**SP ENERGY
NETWORKS**

The Dumfries and Galloway Strategic Reinforcement Project

**Summary of Feedback from 2015
Consultation, which remains
relevant to a revised scheme**

July 2016

Figure 11.1: Proposed Corridors

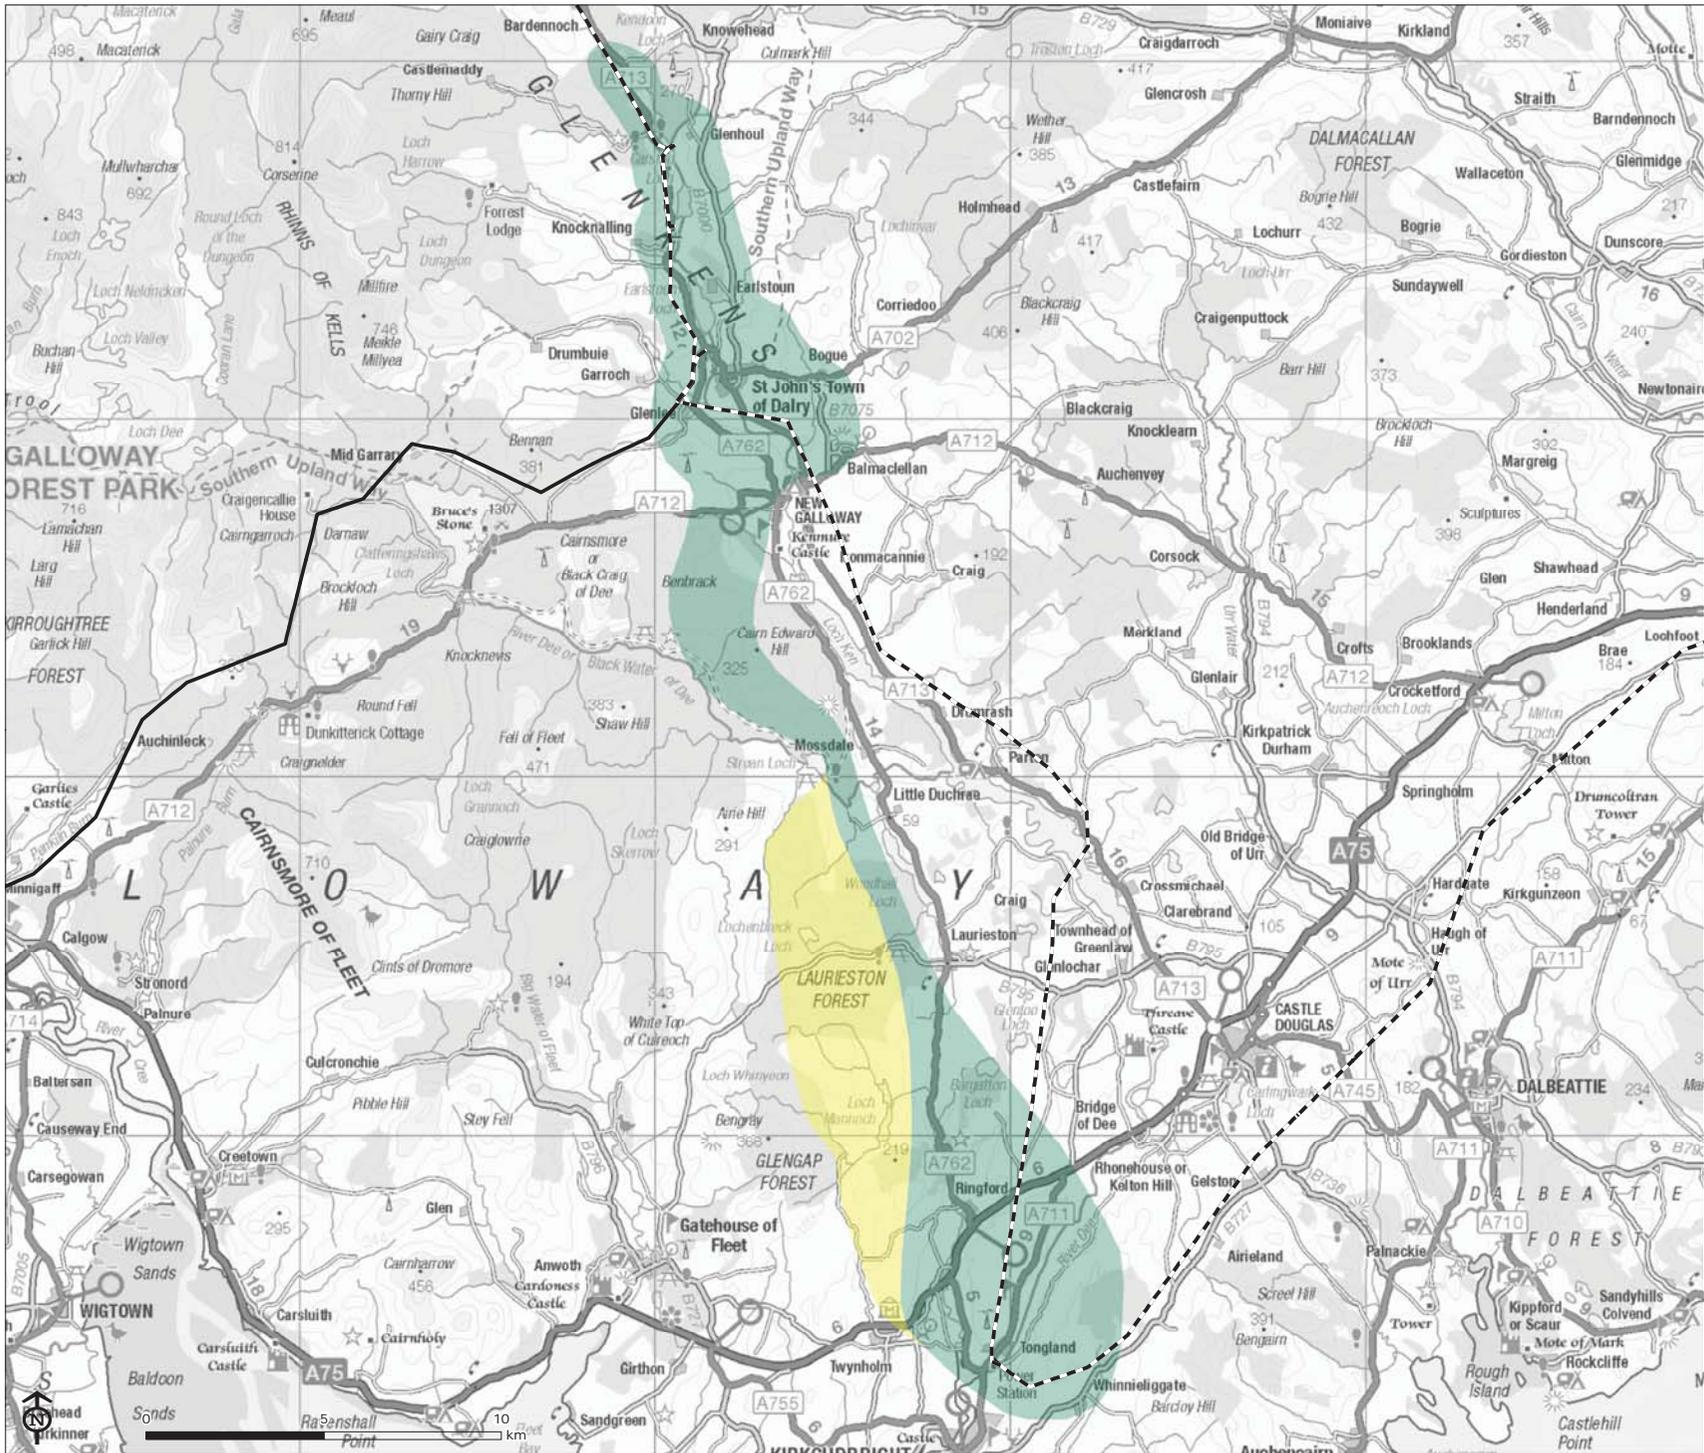
- Corridor G/T 2 has been confirmed as the proposed corridor between Glenlee and Tongland. This corridor has also been extended (widened) as outlined in Chapter 8, paragraph 8.2.51 and shown in figure 11.1. This corridor will now be progressed to the next stage of the routeing process; and
- Corridor K/G 1 has been confirmed as the proposed corridor between Kendoon and Glenlee as outlined in Chapter 8 and shown in figure 11.1. This corridor will now be progressed to the next stage of the routeing process

- 11.3.6 On this basis SPEN's proposed corridors are set out below by consultation zone and are shown on the map in **Figure 11.1**.

Zone 3: Glenlee to Tongland (see Figure 11.1)

Zone 4: Glenlee to Kendoon (see Figure 11.1)
